Modification Recommended Service Note

P5005A Keysight Streamline USB Vector Network Analyzer

Serial Numbers: From MY58100426 to MY58100451

Potential lifted front panel overlay

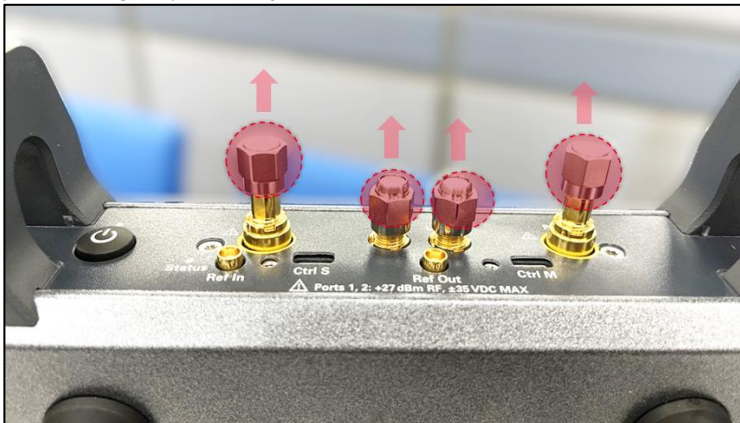
Keysight streamline series vector network analyzer (VNA) of serial number range identified in service note cover page might potentially exhibit the following lifted front panel overlay symptom.

Apart from cosmetic imperfections, the lifted front overlay could have led to non-fully attached *Ctrl S* micro-HDMI cable connector in multi-VNAs setup configuration.

-> Apply this service note only if end users' VNA is exhibiting the following symptom.

Procedure to replace the front panel overlay.

1. Remove the front handles. Detach the 50-ohm termination (LO-In, LO-Out, Port 1 & Port 2) or protecting caps if they are attached to the VNA.

2. Pry open the existing front panel overlay and remove it from front panel.
3. Clean the metal surface thoroughly and ensure it is free of adhesive residue.
4. Affix the new self-adhesive front panel overlay onto the metal surface.
5. Reinstall (reuse) the 50-ohm terminations or protecting caps accordingly.

6. Reinstall (reuse) the front handles.
